Central Planning Authority

Minutes of a meeting of the Central Planning Authority held on September 1, 2021 at 10:00 a.m. in Conference Room 1038, 1st Floor, Government Administration Building, Elgin Avenue.

CPA/18/21

Figure 3: Survey data showing shoreline position/MWHM from 2003 to 2019 on 2018 aerial imagery

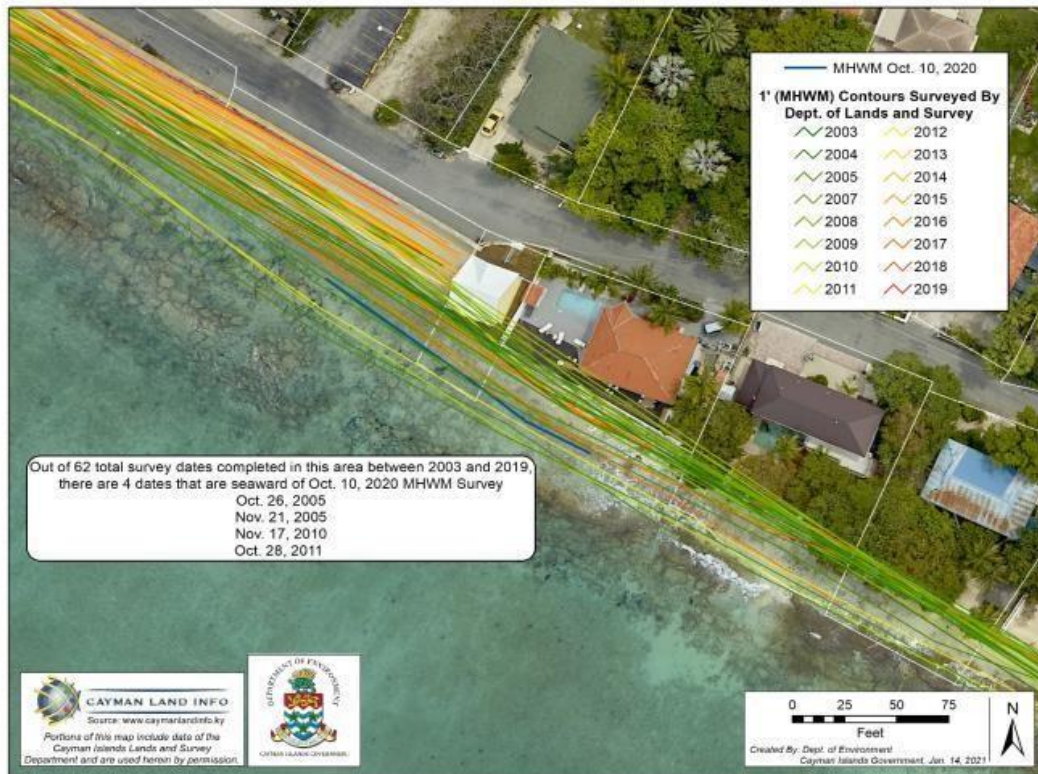
Figure 3 shows the surveyed position of the shoreline/MHWM at frequent time intervals from 2003 to 2019 (approximately monthly), based on survey data collected by the Department of Lands & Survey. Out of a total of 62 surveys undertaken in this location between 2003 and 2019, there were only 4 dates when the beach existed seaward of the October 2020 MHWM. Of these, the October and November 2005 accretion events can be attributed to Hurricane Wilma. The October 2011 accretion may be attributed to Hurricane Rina. Furthermore, as can be seen from Figure 3, the beach was completely absent for many of the survey dates (22).

The current MHW survey reveals that the current seawall forms the boundary with the sea, and to the west of the site, incursion of the sea can be sea up to the Boggy Sand Road sheet piled seawall. Therefore, whilst the proposed seawall is positioned marginally further inland than the existing, the proposed seawall will also have a 0ft setback from the sea. The proposed cabana will have an 8ft setback from the existing seawall and an even lesser setback from the proposed seawall location.

Figure 4. Seawalls cause scour as the energy is reflected by the seawall.

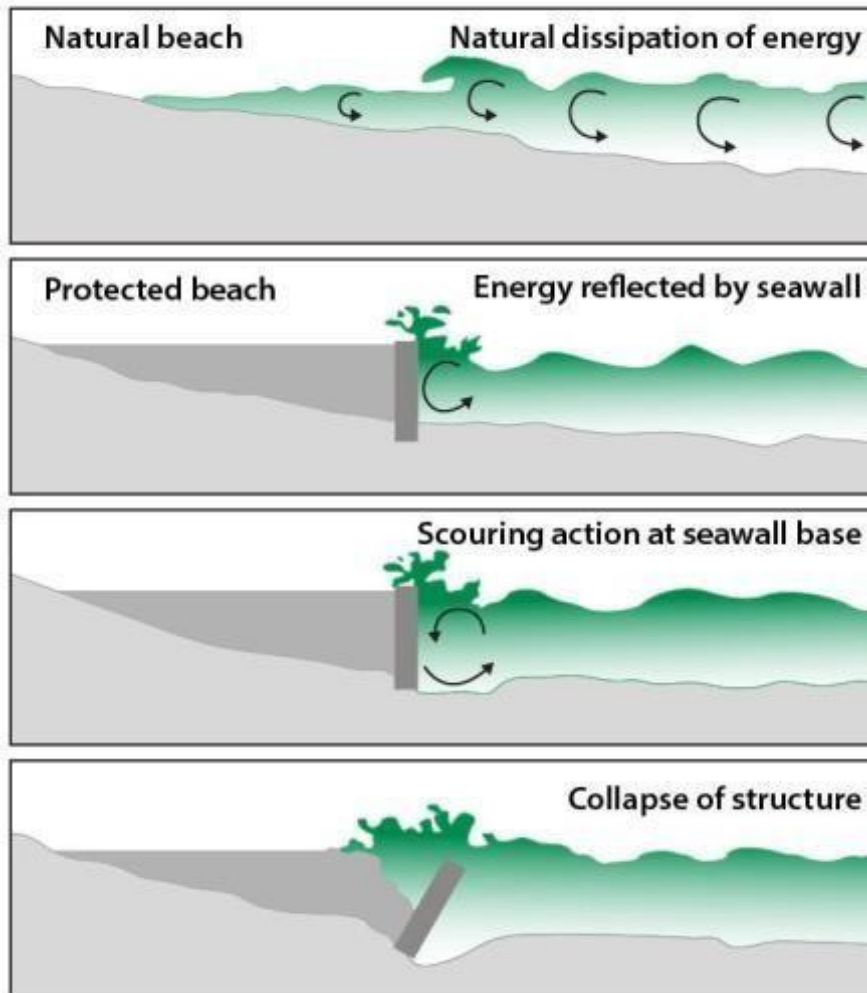
Hard structures such as seawalls on a beach, restrict the natural sand deposition processes. On a natural undeveloped beach, waves roll up the beach, depositing sand as they lose energy. However, seawalls interfere with this process. When waves hit a seawall, the energy is directed downwards and sideways. When the energy is directed downwards, the waves scoop out the sand at the foot of the seawall – called scour (see Figure 4). The existing seawall has caused scour at the site, as detailed in the

Engineering Report which accompanies the planning application. When the energy is directed sideways, the wave flanking can remove sand from neighbouring properties. Therefore, this seawall could also be negatively affecting the beach on adjoining parcels.
